CHANGE REQUEST

PROPOSAL REQUEST

Marshall County Courthouse PROJECT NO: 18827003

PR NO.: 015

02 26 02 EXISTING ELECTRICAL PANELED WALL TO REMAIN, MODIFY PANELS AND POINT TO MATCH ADJACENT

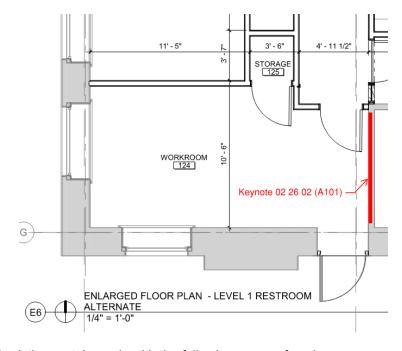
Please consider the following replacement scope of work for the existing electrical panel in workroom 124:

- 1. **REPLACE** modification & painting of existing metal panels with the following scope of work.
 - a. Have Electrical Contractor Ensure the Panels are not connected to power.
 - b. Remove Panel doors/covers back to steel frame
 - c. Install plywood, and 5/8" gypsum wall board to flush out with surrounding gypsum board. Verify plywood thickness on site, shimming may be required to flush out the gypsum board wall surfaces.
